Agreement No. CE 92/2017 (CE) Site Formation and Infrastructure Works for Public Housing Development near Tan Kwai Tsuen, Yuen Long – Investigation, Design and Construction

Draft Sewerage Impact Assessment Report for S16 Planning Application (Intensification Scheme) 199086/BIN/090/Issue 4

# Responses to Comments on Draft Sewerage Impact Assessment Report for S16 Planning Application (Intensification Scheme) (Issue 3)

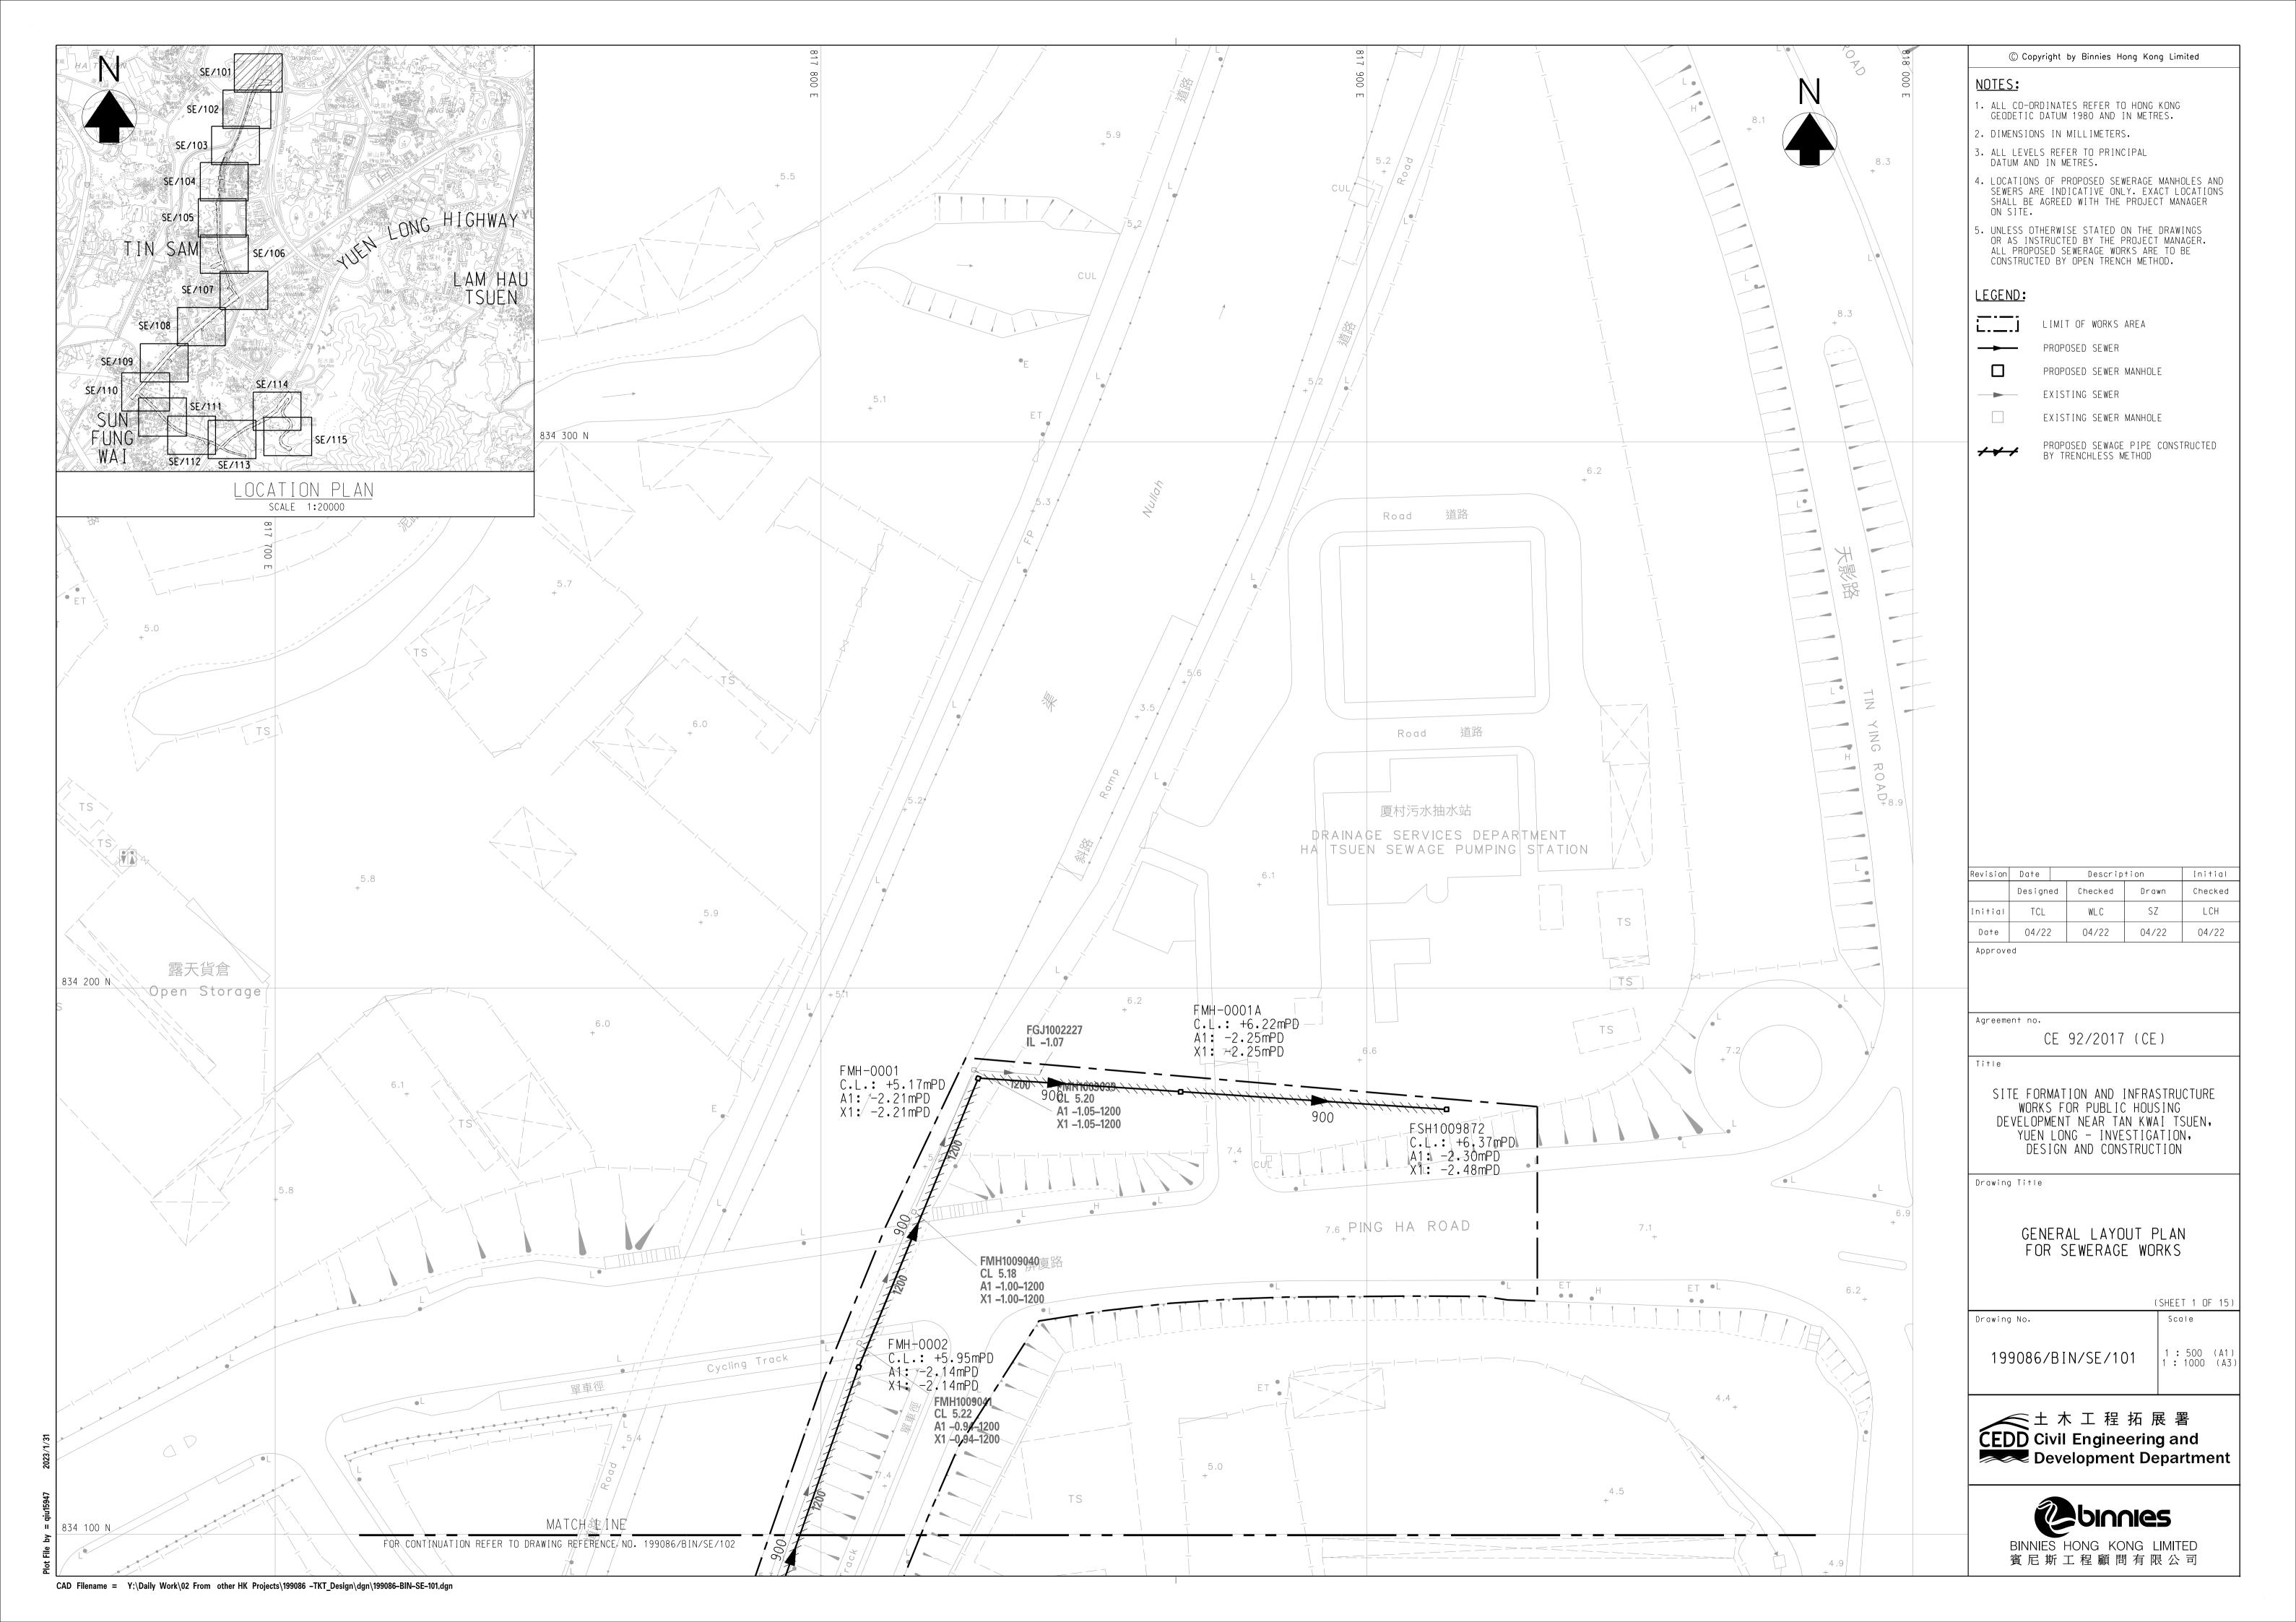
Comments	Responses
Drawing 199086/BIN/SE/101 and Appendix A2: please also check the invert level of manhole FMH-0001 and FMH-1001A which are not consistent with Appendix A2	Drawing 199086/BIN/SE/101 and Appendix A2 have been updated for consistency.
Appendix A2: noted that utilization of some pipe reaches 98%, suggest to use larger pipes to cater for overflow due to transient flow/surge and make allowance for future developments in the region.	The concerned sections FMH-0037 to FMH-0034 which reach 98% utilization have been reviewed and upgraded with a steeper gradient.

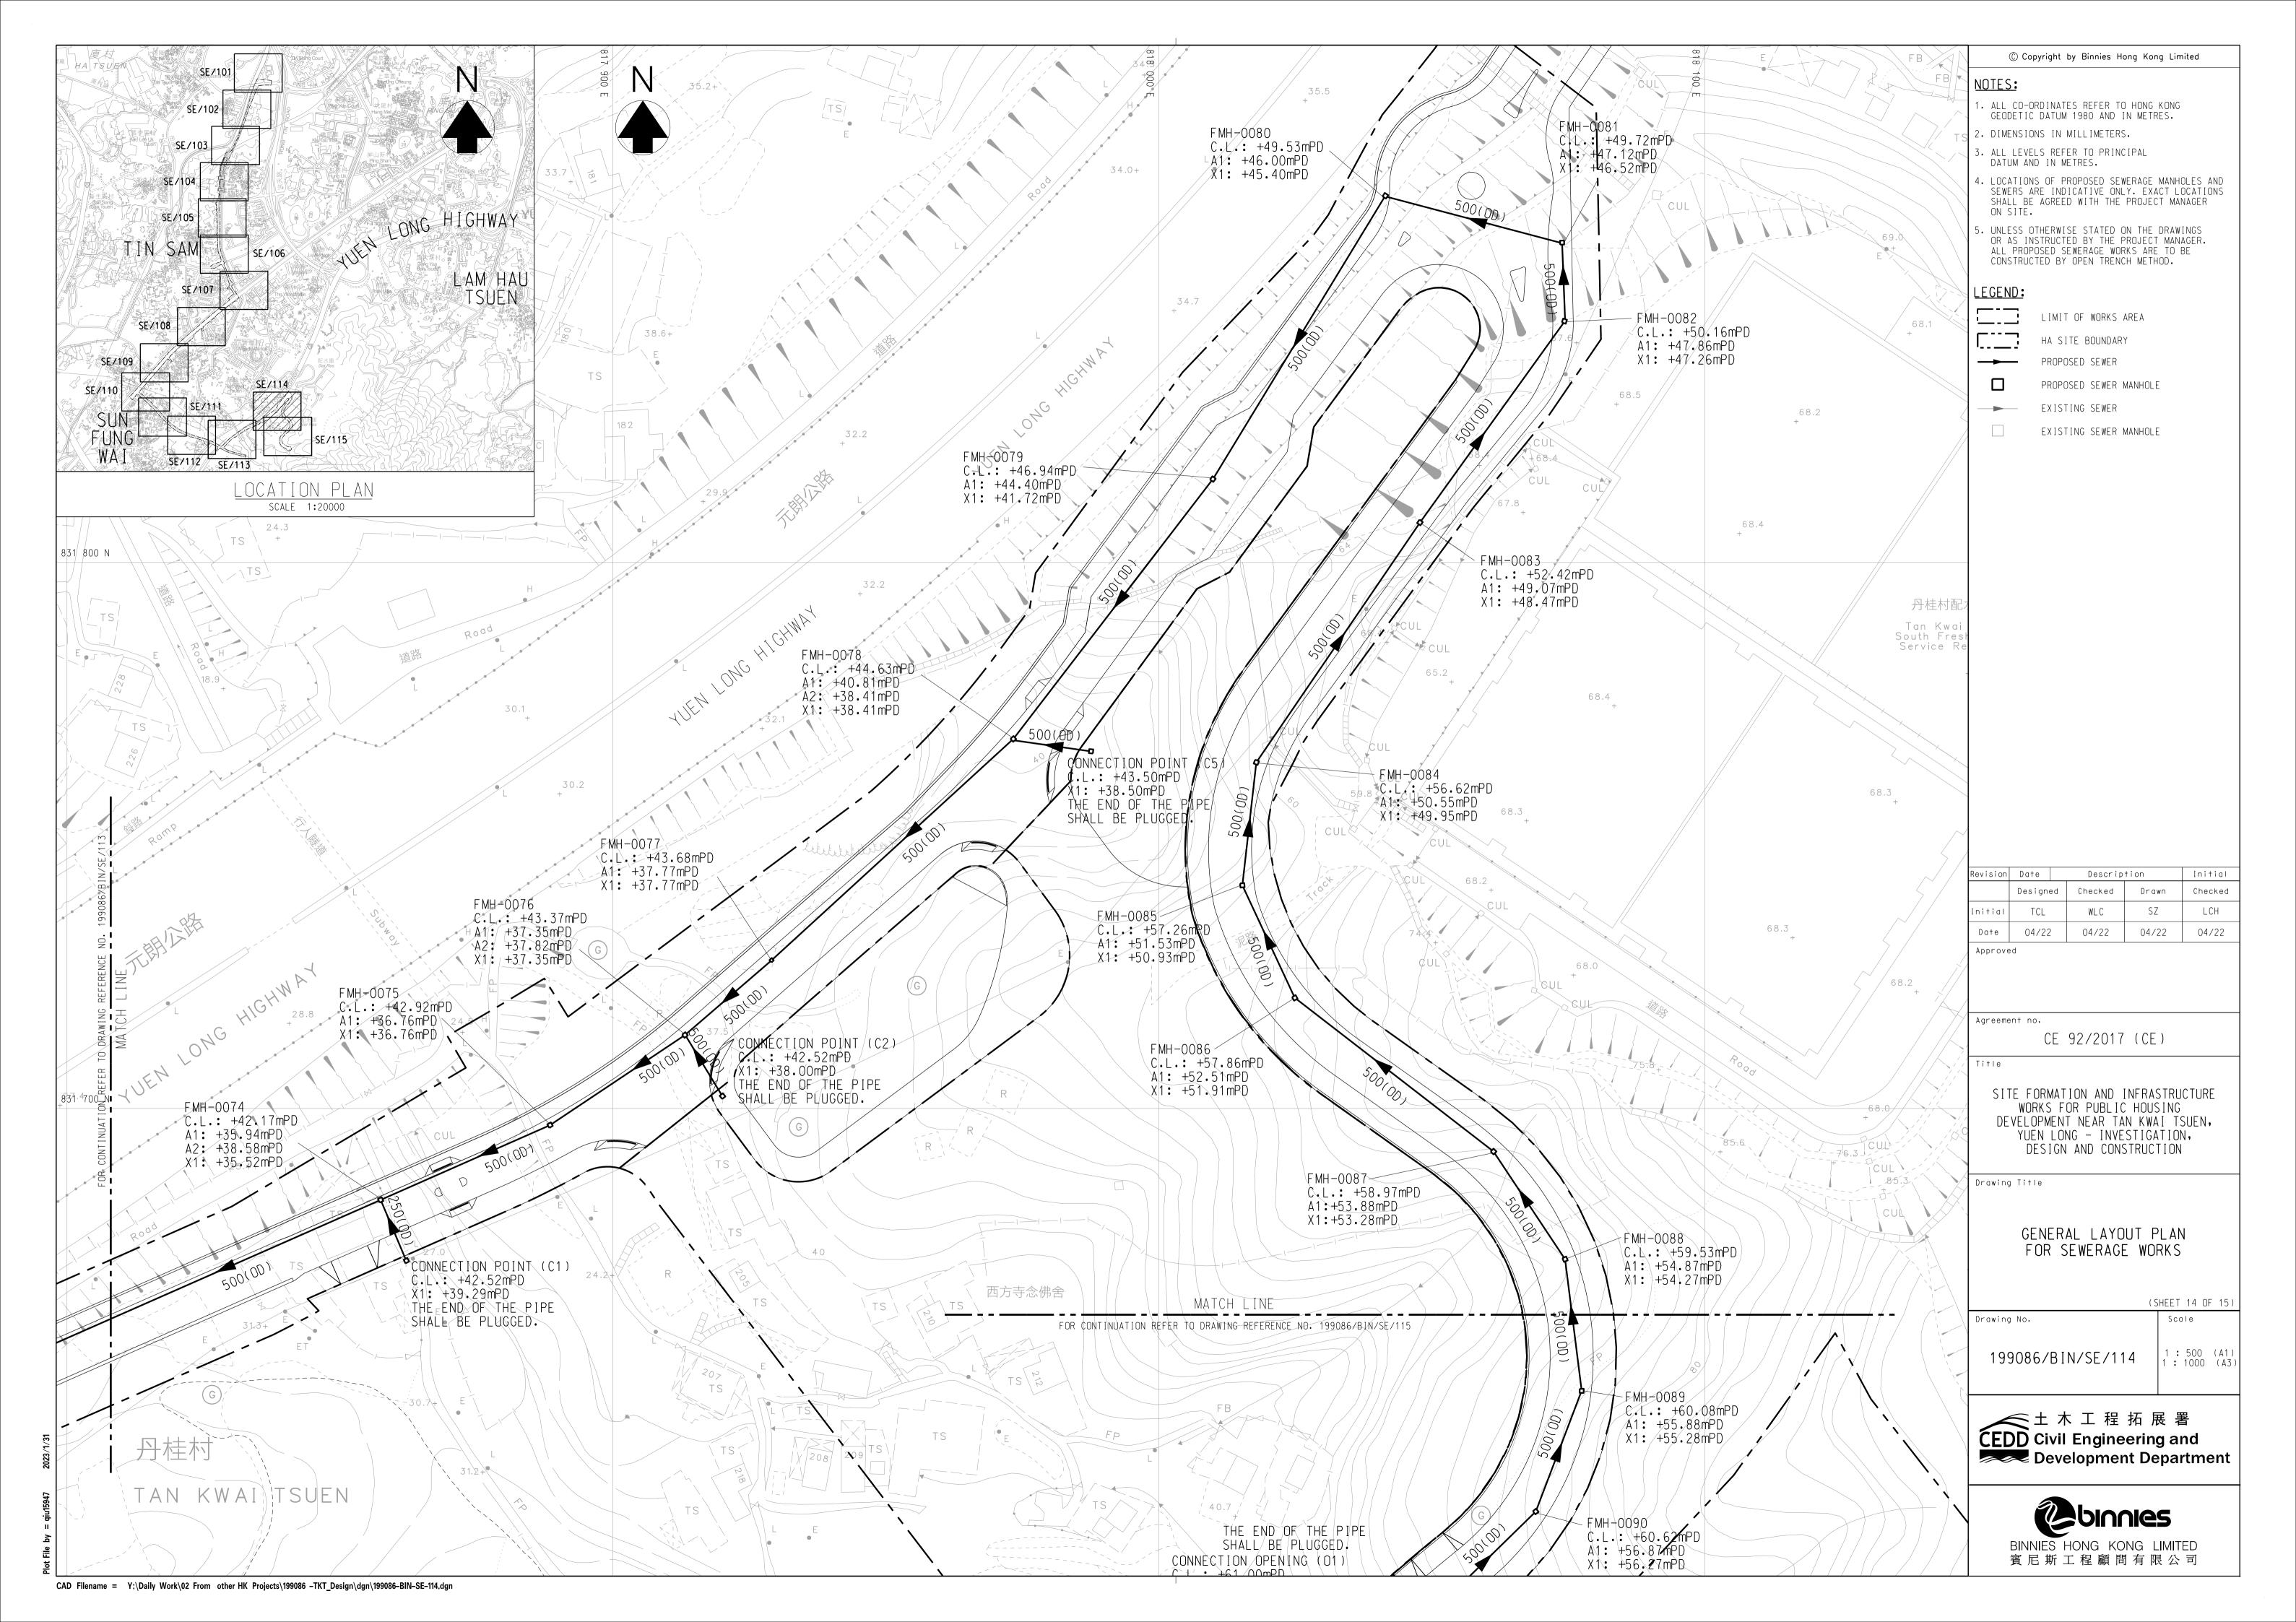
Drawing 199086/BIN/SE/114 and Appendix A2: X1 of connection point C1 and A2 of manhole FMH-0074 shown in the drawing are not consistent with the invert level of sewerage pipe C1 to FMH-0074 in Appendix A2	Drawing 199086/BIN/SE/114 and Appendix A2 have been updated for consistency.
